Salem Generating Station, Units 1 and 2
Renewed Facility Operating License Nos. DPR-70 and DPR-75
NRC Docket Nos. 50-272 and 50-311

Subject: Salem Generating Station Unit 2 Compliance with March 12, 2012 NRC Order to Modify Licenses with Regard to Reliable Spent Fuel Pool Instrumentation (Order Number EA-12-051) and Responses to Requests for Additional Information for Salem Units 1 and 2

Salem Generating Station Units 1 and 2 Response to Interim Staff Evaluation and Request for Additional Information Regarding the Overall Integrated Plan for Implementation of Order EA-12-051, "Reliable Spent Fuel Pool Instrumentation"

Figure 1 - Typical Mounting Sketch (Not to scale)
Ref: PSEG Drawing 606366

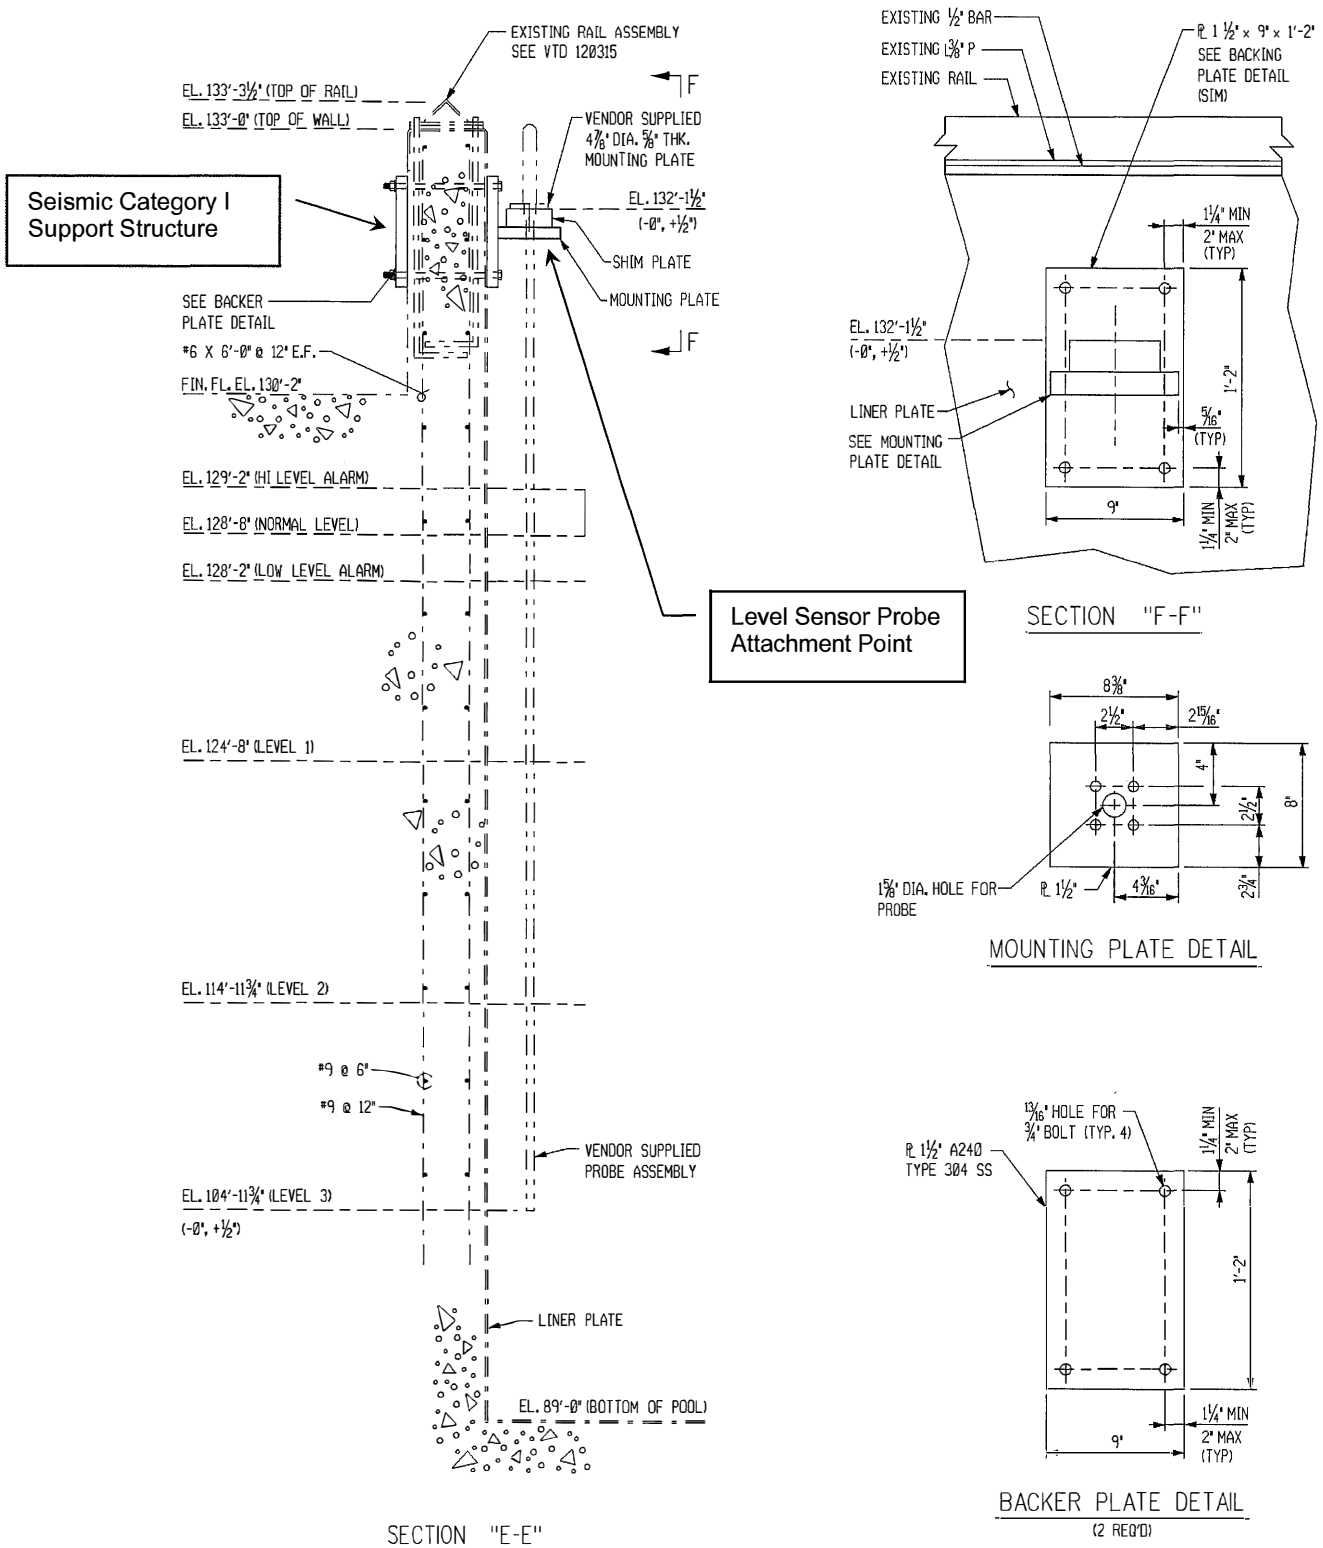
- a) The design criteria that will be used to estimate the total loading on the mounting device(s), including static weight loads and dynamic loads. Describe the methodology that will be used to estimate the total loading, inclusive of design basis maximum seismic loads and the hydrodynamic loads that could result from pool sloshing or other effects that could accompany such seismic forces.

- b) A description of the manner in which the level sensor (and stilling well, if appropriate) will be attached to the refueling floor and/or other support structures for each planned point of attachment of the probe assembly. Indicate in a schematic the portions of the level sensor that will serve as points of attachment for mechanical/mounting or electrical connections.

- c) A description of the manner by which the mechanical connections will attach the level instrument to permanent SFP structures so as to support the level sensor assembly.

- a) The design criteria used to estimate total loading, including static and dynamic loads are the SGS safety related design basis for Seismic Category I components in accordance with PSEG Technical Standard "Salem Structural Design Criteria" (Reference 3). The SGS Units 1 and 2 Structural Design Criteria provide both the criteria and the methodology used for determining total loading. The loading on the probe mount and probe body includes both seismic and hydrodynamic loading by utilizing seismic response spectra that bound SGS design maximum seismic loads applicable to the installed locations. The static weight load is accounted for in the analytical model performed by the instrument vendor using the methodology provided in IEEE 344-2004.

- b) Each level sensor is mounted to a support structure that is designed to Seismic Category I requirements. Salem is using the Mohr EFP-IL design, which does not include a stilling well. The support structure is anchored to the concrete curb around the SFP above the refueling deck as shown in Figure 1. The anchorage of the level probe mount is analyzed for Seismic Category I requirements in accordance with the SGS Units 1 and 2 structural design criteria (Reference 3), and documented in SGS calculation 6S0-2345 (Reference 4).
- c) The level sensor is designed to be attached near its upper end to the Seismic Category I support structure designed specifically to fit the SGS Unit 1 and 2 SFPs as shown in Figure 1.
